January 31, 2013/February 7, 2013

Response to RFIs from the Temple, TX VA Diesel Tank Relocation Project

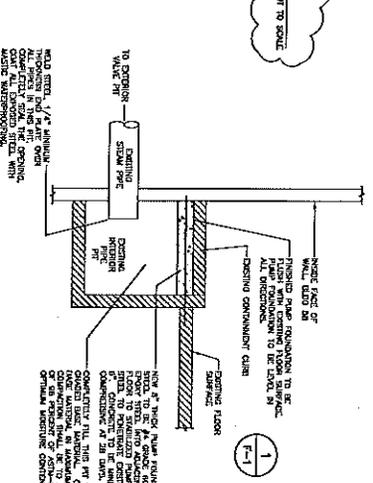
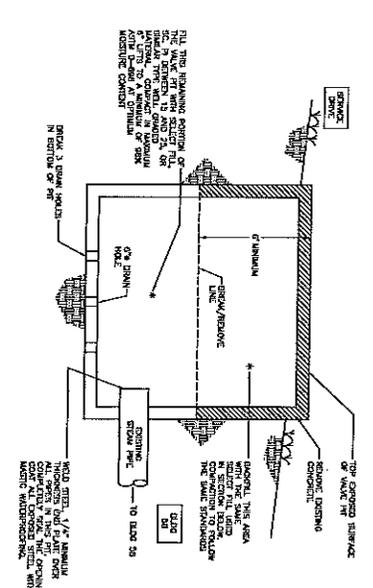
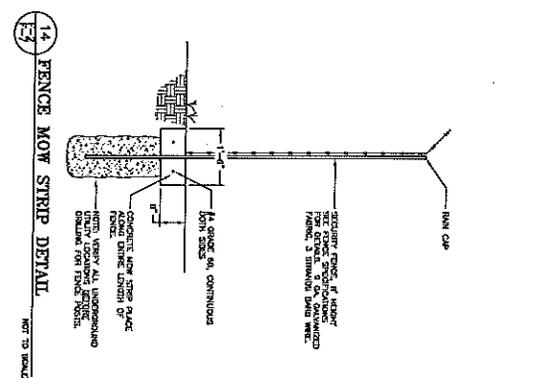
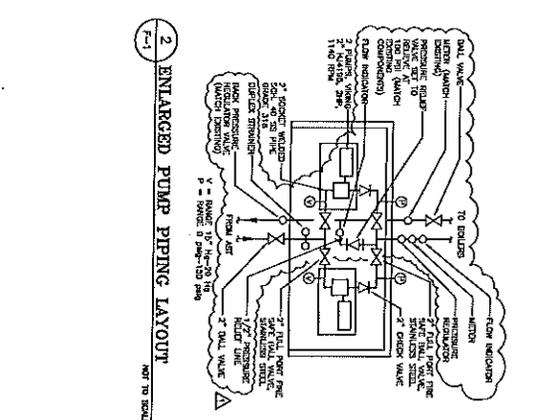
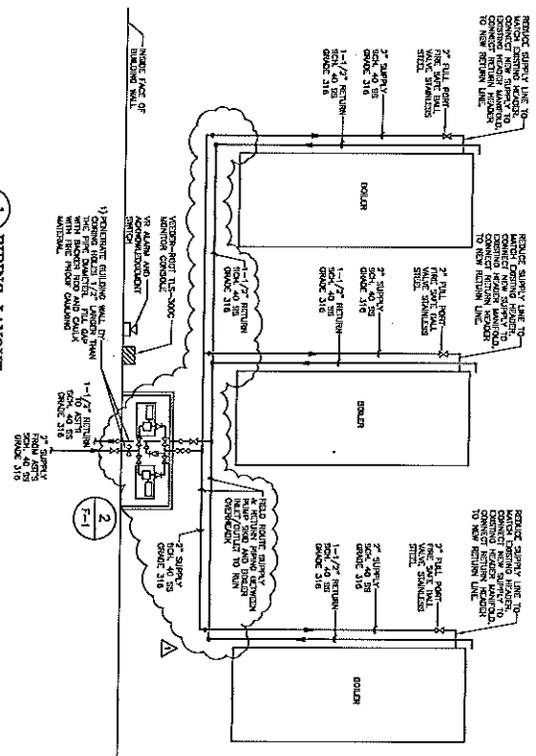
9. There are areas in the fittings and piping that do not appear to meet the VA "Standard Piping Diagram."
 - A. Sheet F-1 has been revised to reflect additional fittings as included in the VA "Standard Piping Diagram." See attached sheet for additional information.
